# UNITED STATES PATENT AND TRADEMARK OFFICE

APPLICATION NO.	FILING DATE	FIRST NAMED INVENTOR	ATTORNEY DOCKET NO.	CONFIRMATION NO.
09/683,354	12/18/2001	Joseph Neyman	neyman	3946

**Office Action Summary**

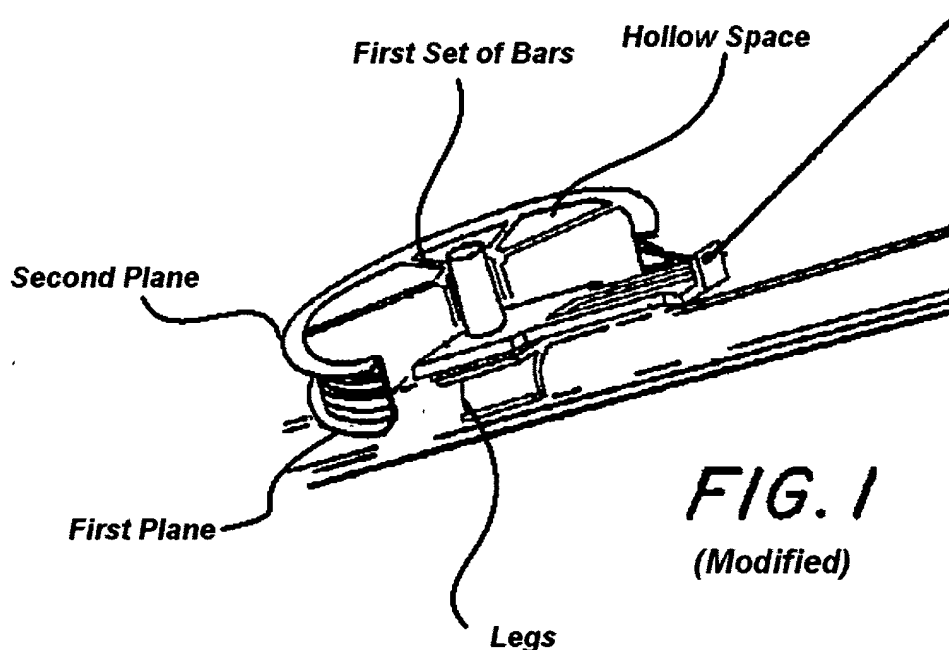
Sherbondy discloses a fishing line apparatus comprising a first elongate plane, a first set of bars, a second set of bars communicating with the first plane (not shown in figure 1, as it a cutaway of the cross-section), a series of legs communicating with the first plane for attaching to the rod of the fishing pole, a generally elongate second plane communicating with the first and second set of bars wherein the first plane and second plane are generally elongate (as they have a length) in parallel to the rod of the fishing pole (see figure below).

Regarding claim 12, Sherbondy disclose a hollow space between the first and second set of bars communicating with the first and second planes.

Regarding claim 13, Sherbondy discloses the first and second series of bars creating curvatures from the middle to the exterior of the plans
